**ADDENDUM NO 1
TO
CONTRACT DOCUMENTS
FOR
FINISHED WATER PUMP VAULT VENTILATION

DISTRICT PROJECT NO. 4371

7/9/2026**

FINISHED WATER PUMP VAULT VENTILATION

A FINISHED WATER PUMP AREA - PLAN
SCALE: 3/16" = 1'-0"
FILE: 02-M-24

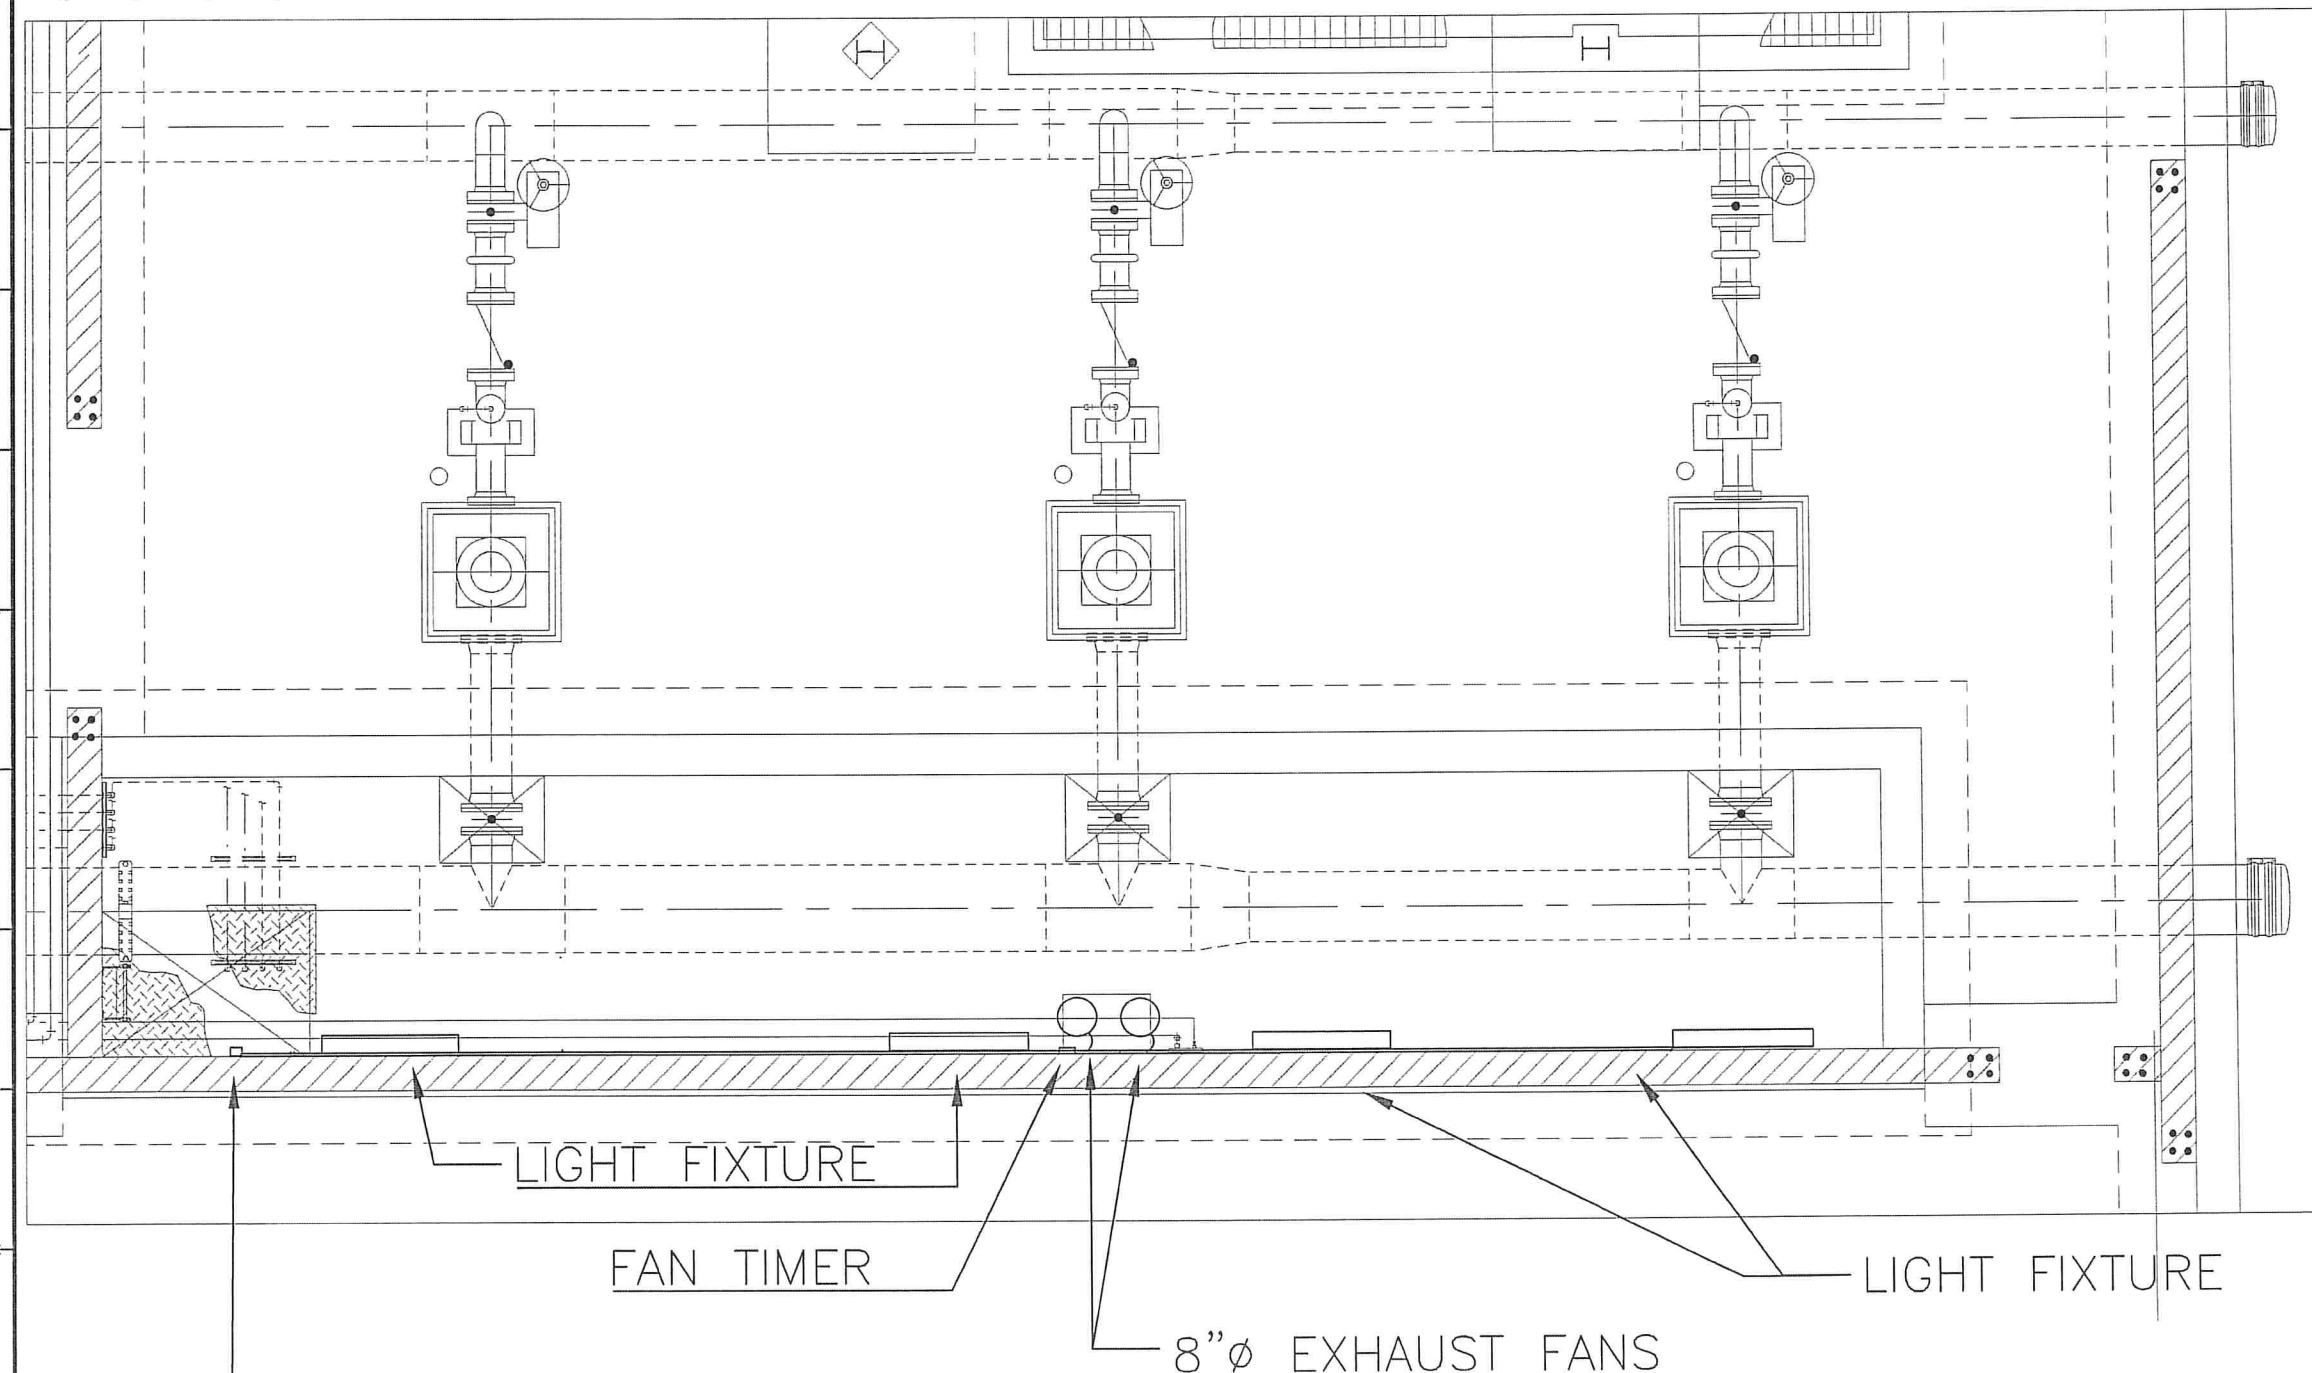
1. Bidding document pages M2, E1, and E2 contain slight changes listed below.
2. A. Fan and vent piping may be square cut at the ends rather than cut at a 45°. B. Lighting for the vault should include 4 wall mounted light fixtures 84" above finished floor rather than 3 ceiling mounted light fixtures.

1. NEW WORK SHOWN BOLD ON REFERENCE BACKGROUND
2. PULL 120 VAC POWER FROM LP-111, CIRCUIT 33 (EXISTING SPARE BREAKER) TO VCP-2690
3. USE RIGID CONDUIT SIZED ACCORDING TO NEED
4. USE EXISTING EMPTY CONDUIT FROM LP-111 TO VCP-2690
5. CONTRACTOR SHALL SUBMIT FINAL CONDUIT PLAN FOR REVIEW
6. INSTALL LIGHTING ON EAST WALL 84" ABOVE FINISHED FLOOR
